ADDENDUM NO. 01

From: Craig A. Johnson, P.E.
Crist Engineers, Inc.

Date: July 14, 2025

Project: Arkansas Game and Fish Commission
Ed Gordon Point Remove WMA
Culvert Replacement
Blackwell, Arkansas

SHEET NO.
C-A

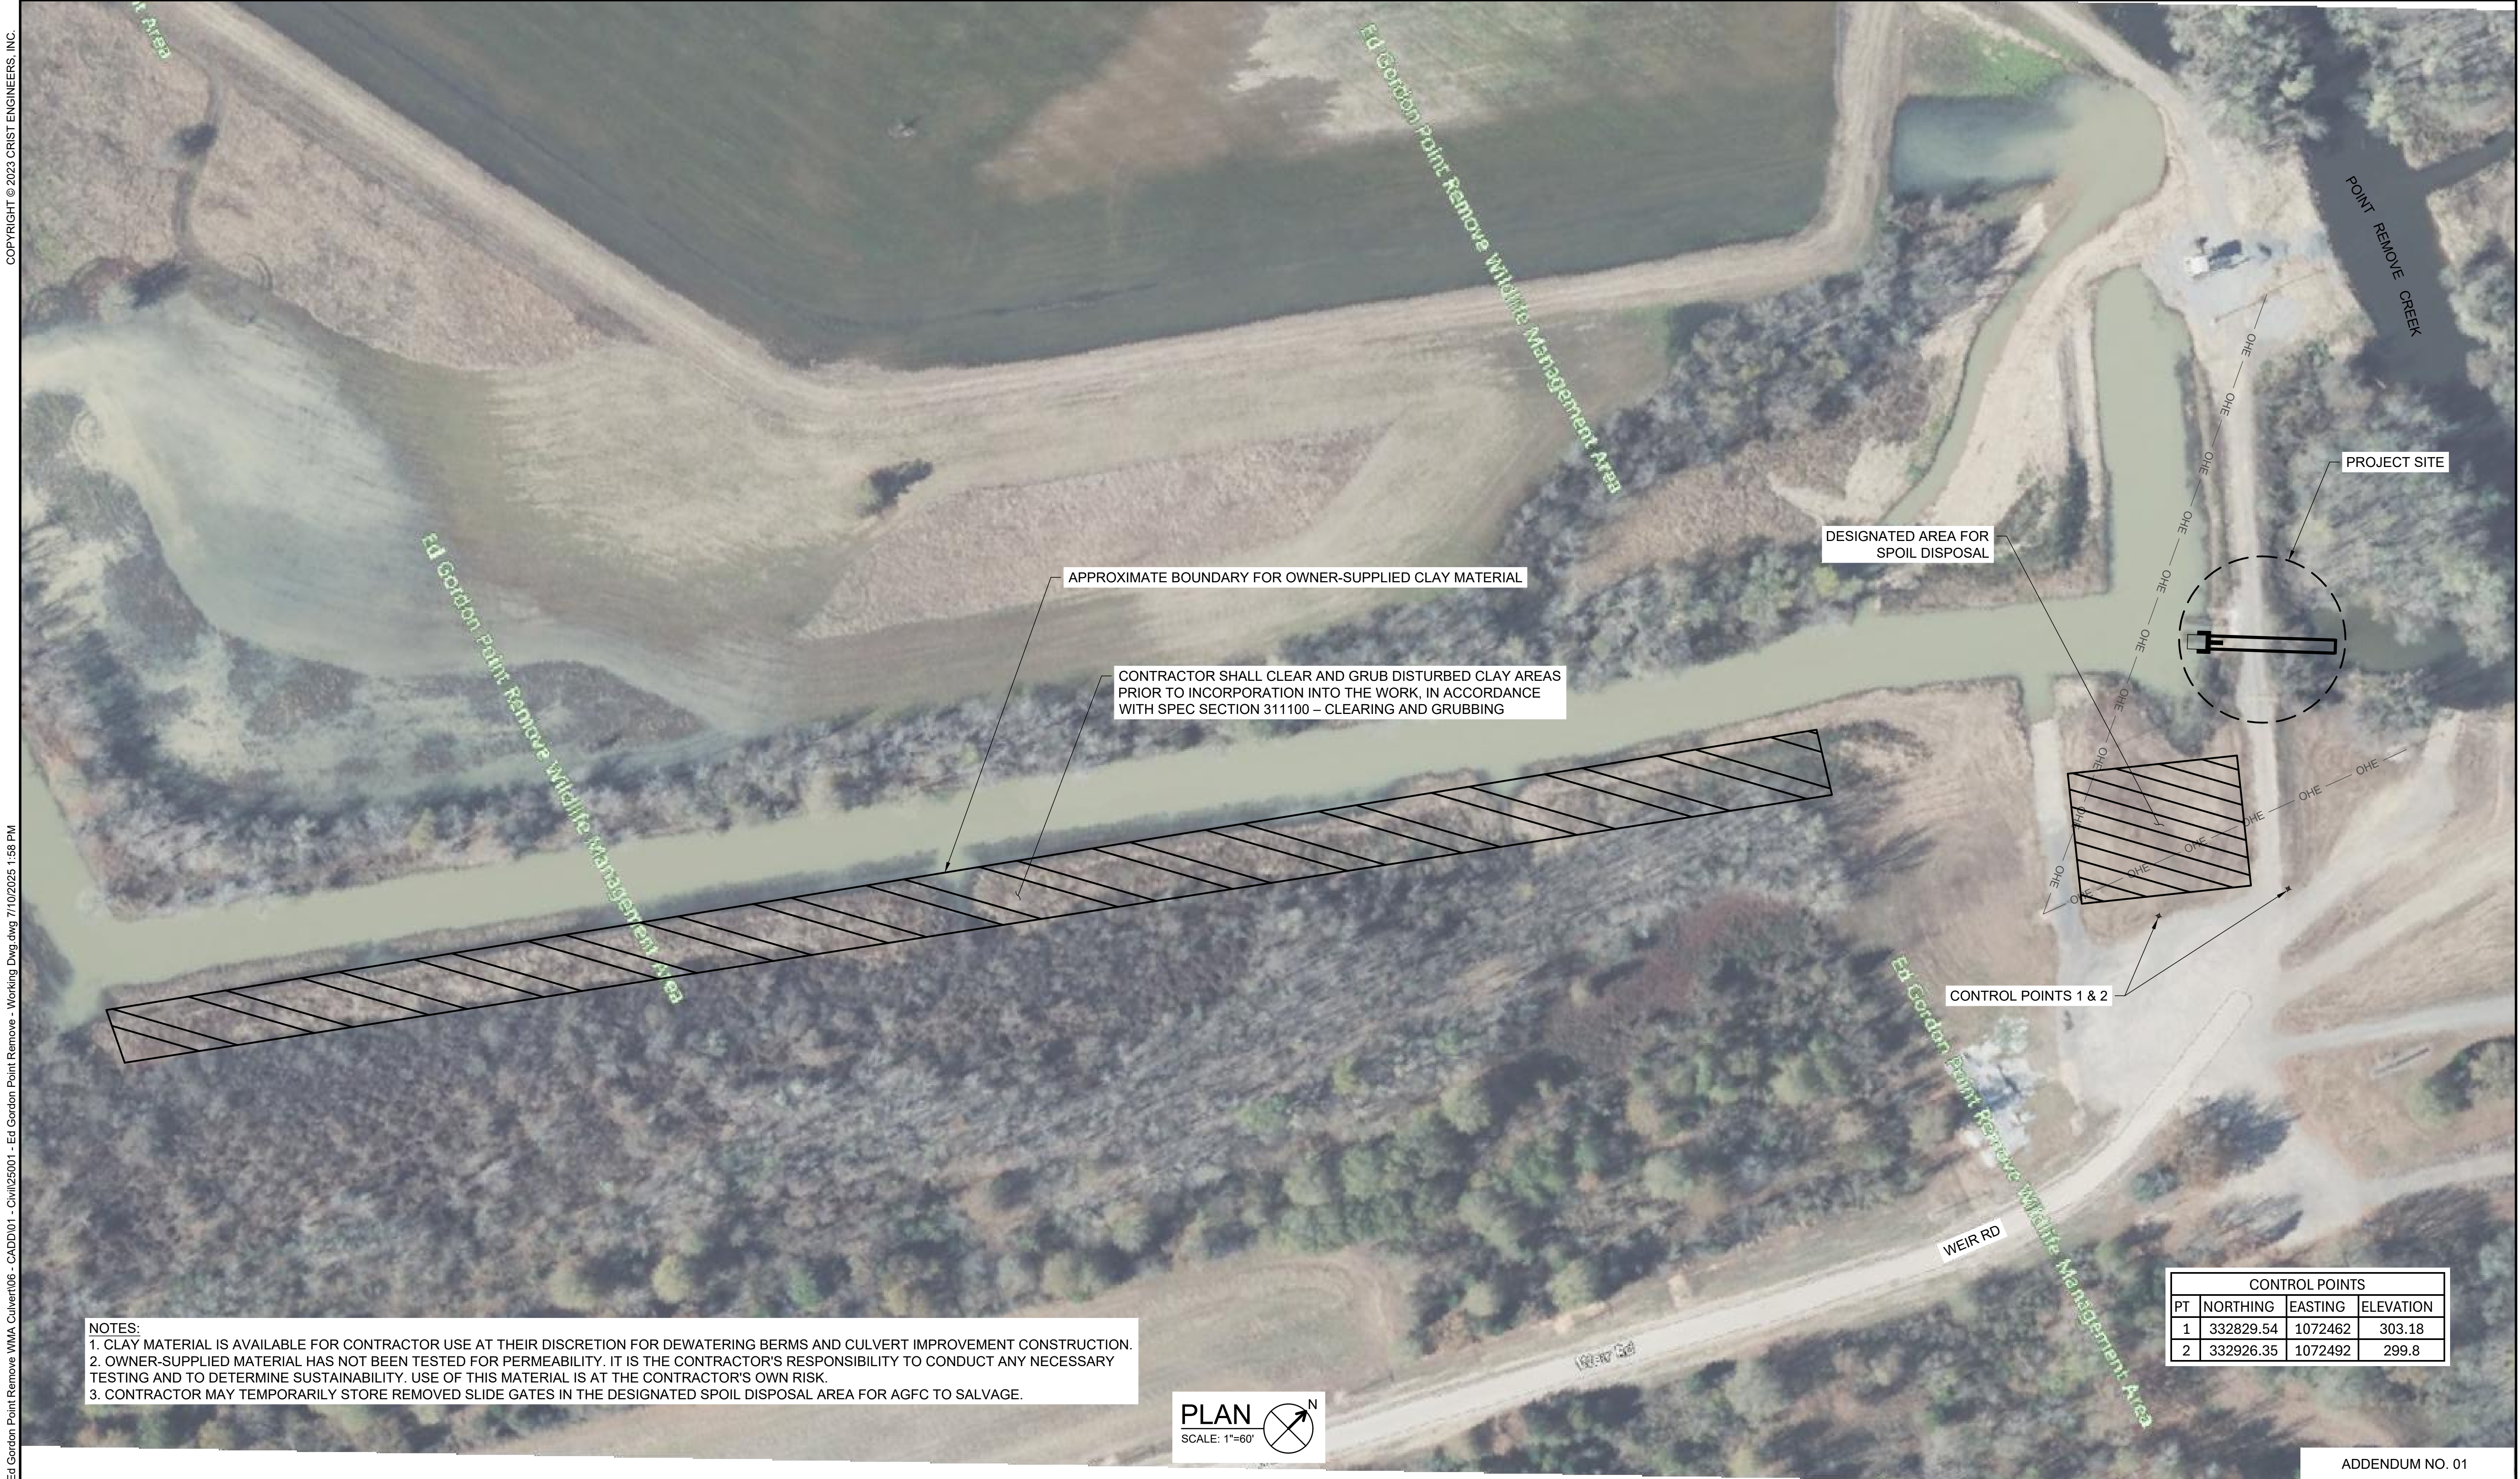
- NOTES:
1. CLAY MATERIAL IS AVAILABLE FOR CONTRACTOR USE AT THEIR DISCRETION FOR DEWATERING BERMS AND CULVERT IMPROVEMENT CONSTRUCTION.
 2. OWNER-SUPPLIED MATERIAL HAS NOT BEEN TESTED FOR PERMEABILITY. IT IS THE CONTRACTOR'S RESPONSIBILITY TO CONDUCT ANY NECESSARY TESTING AND TO DETERMINE SUSTAINABILITY. USE OF THIS MATERIAL IS AT THE CONTRACTOR'S OWN RISK.
 3. CONTRACTOR MAY TEMPORARILY STORE REMOVED SLIDE GATES IN THE DESIGNATED SPOIL DISPOSAL AREA FOR AGFC TO SALVAGE.

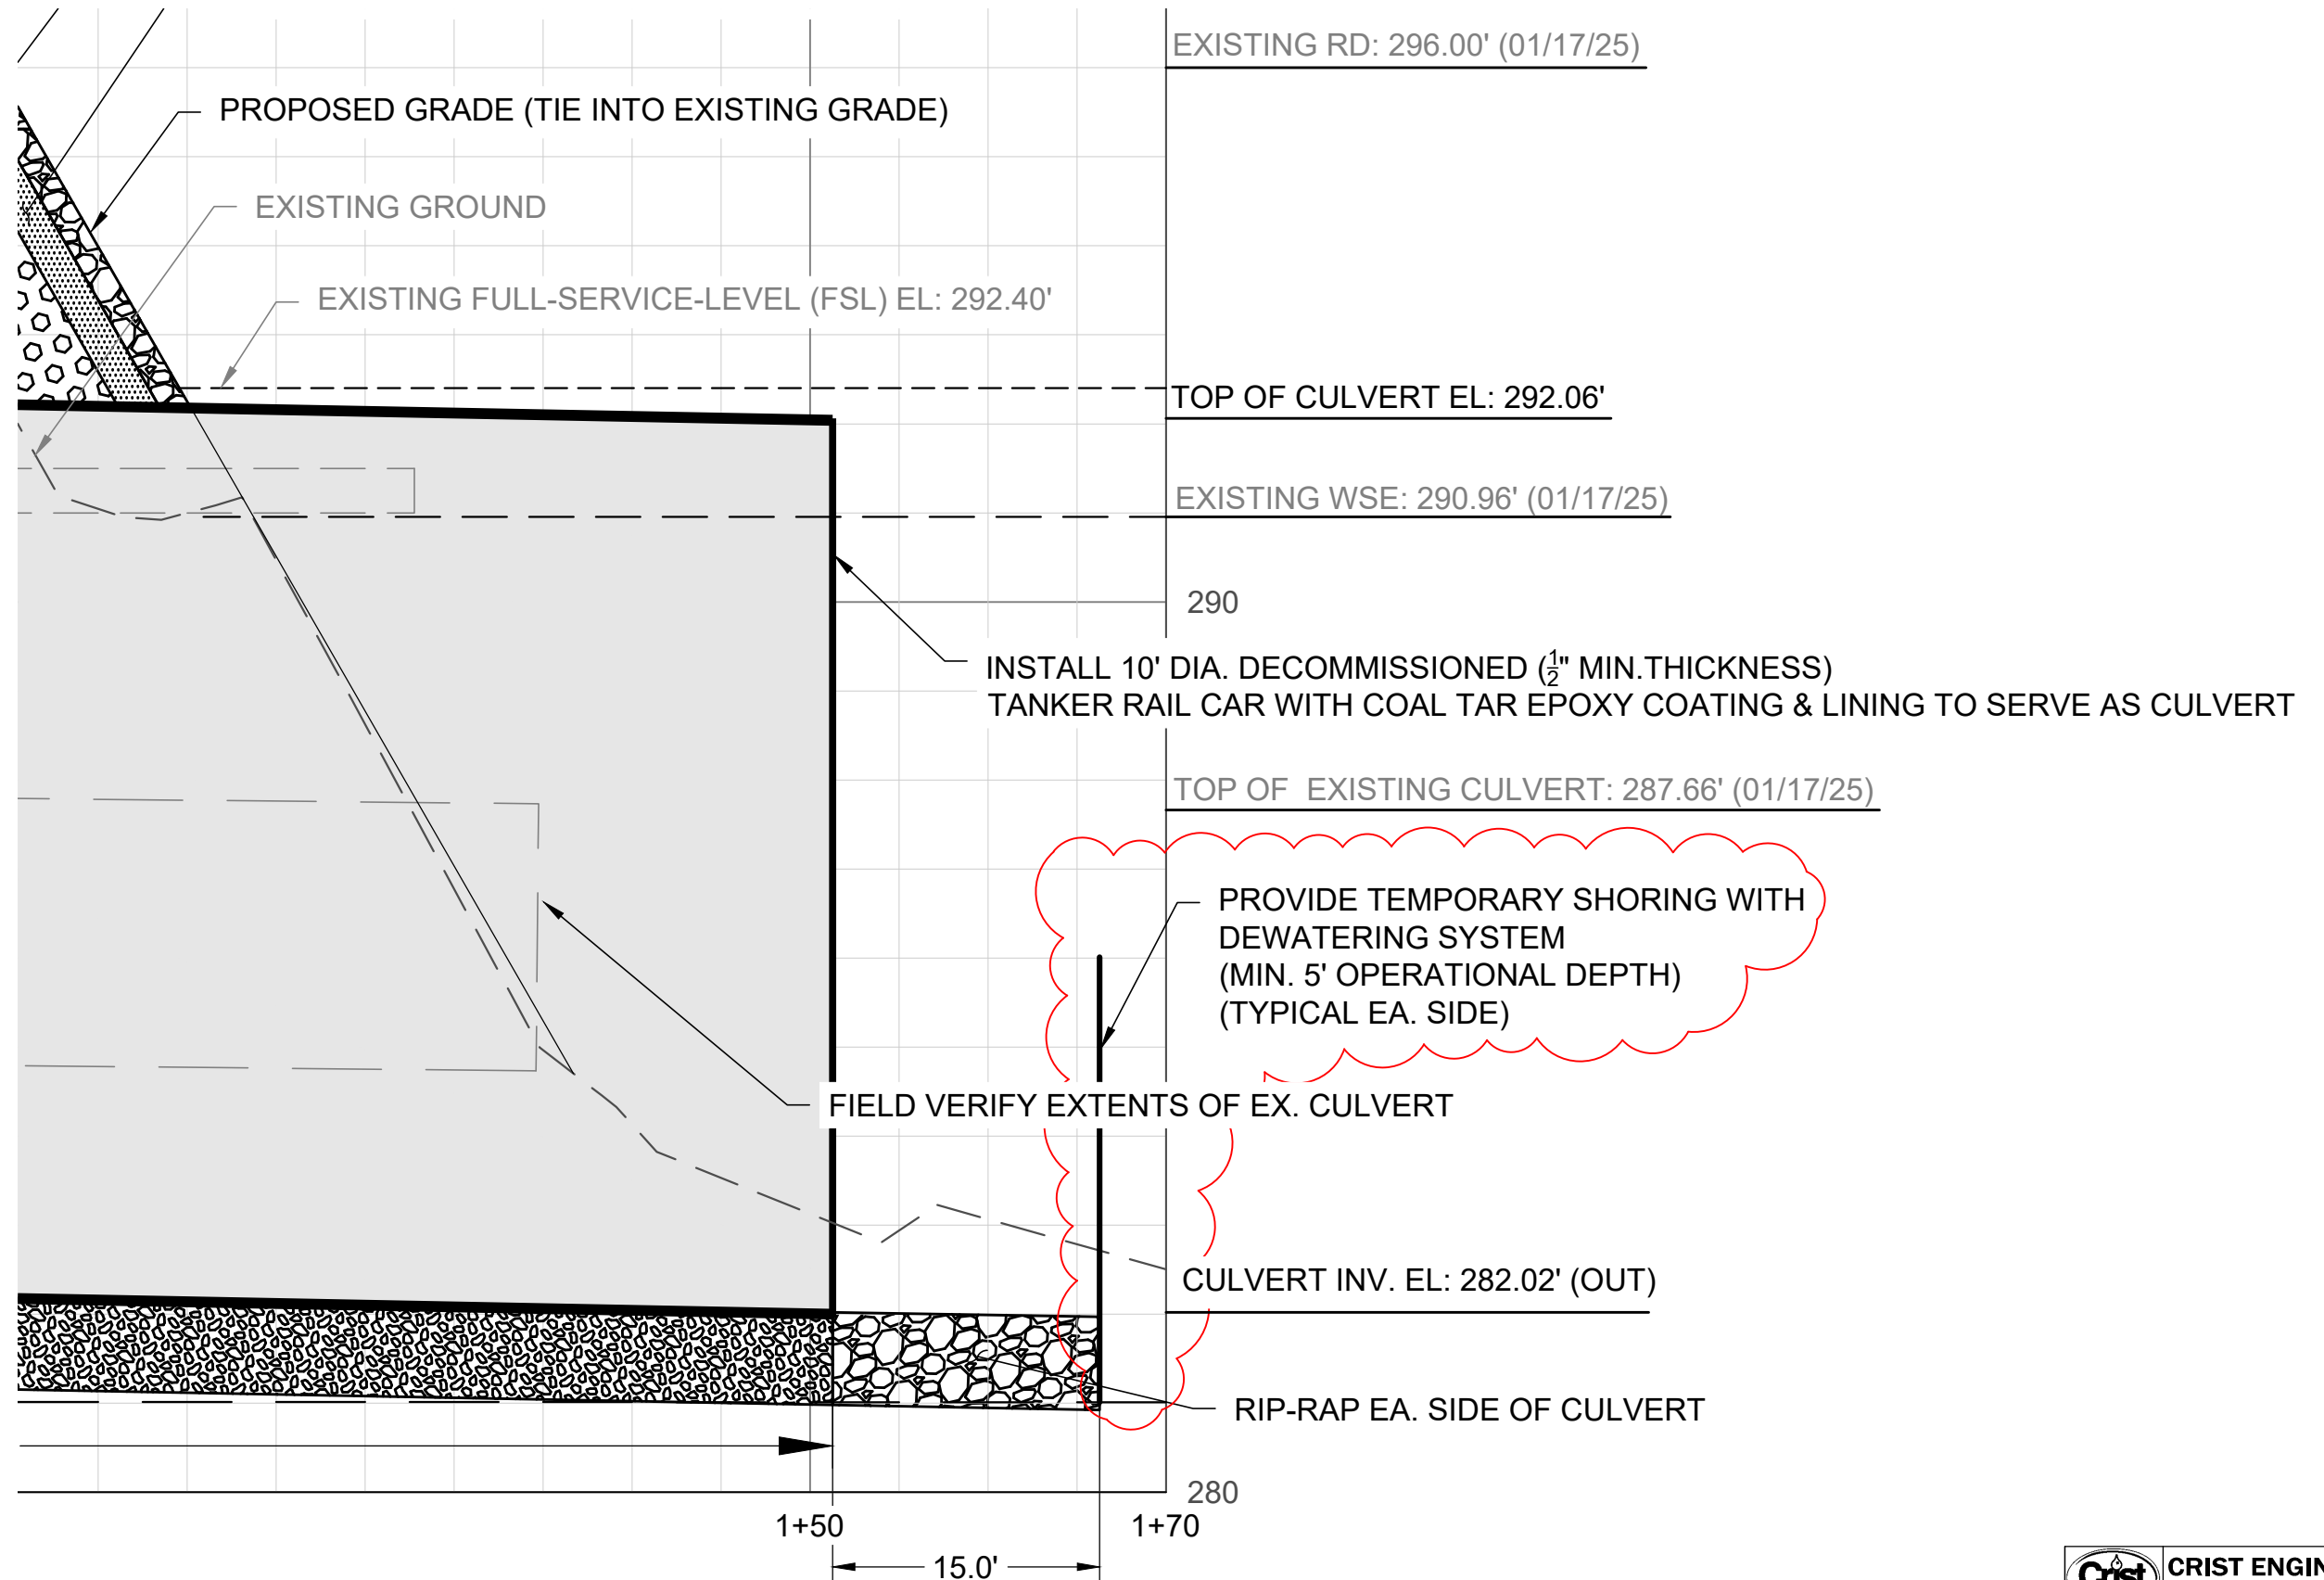
1. Drawing G-3 – General Notes
 - a. Modify note 12.b. Environmental as follows:
The contractor is responsible for preparing a storm water pollution prevention plan meeting Arkansas department of environmental quality requirements. ~~A copy of the SWPPP is to be submitted to Garland County and, if required, ADEQ.~~
2. Drawing C-A – Spoils Management Plan:
 - a. Add new Drawing Sheet C-A as shown on the Addendum No. 1 –Spoils Management Plan, attached hereto.
3. Drawing C-2 – Plan & Profile
 - a. Modify this drawing as shown on the Addendum No. 1 – Dewatering System, attached hereto.
